From: [REDACTED]
Sent: 31/01/2025 4:23:12 PM
To: Council Northernbeaches Mailbox
Cc: Paul McGirr
Subject: TRIMMED: 2024/1698; 71 FLORIDA RD PALM BEACH WRITTEN
SUBMISSION: LETTER OF OBJECTION SUBMISSION: TULLOCH
Attachments: 71 FLORIDA WS.pdf;

SUBMISSION

PAUL McGIRR, 73 FLORIDA ROAD PALM BEACH

RE: 2024/1698
71 FLORIDA RD PALM BEACH
WRITTEN SUBMISSION: LETTER OF OBJECTION
SUBMISSION: TULLOCH

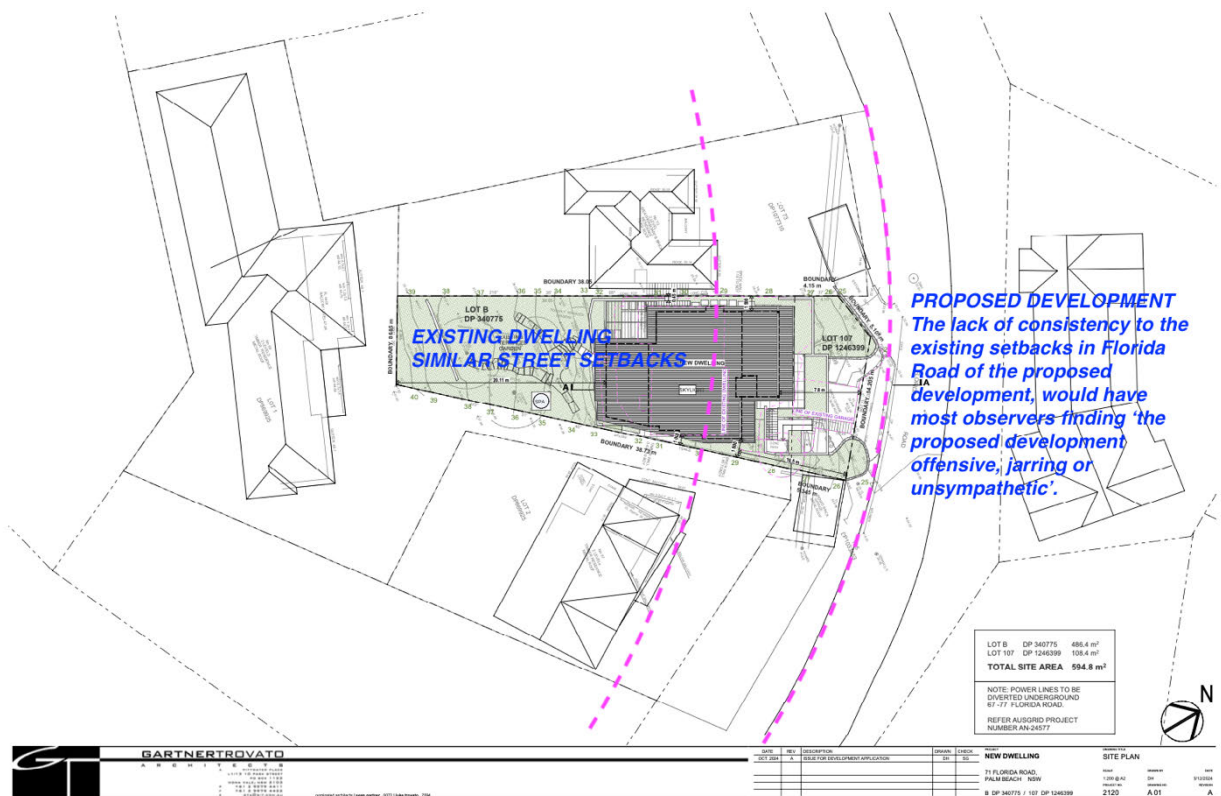
The lack of consistency to the existing setbacks in Florida Road of the proposed development, would have most observers finding 'the proposed development offensive, jarring or unsympathetic'.
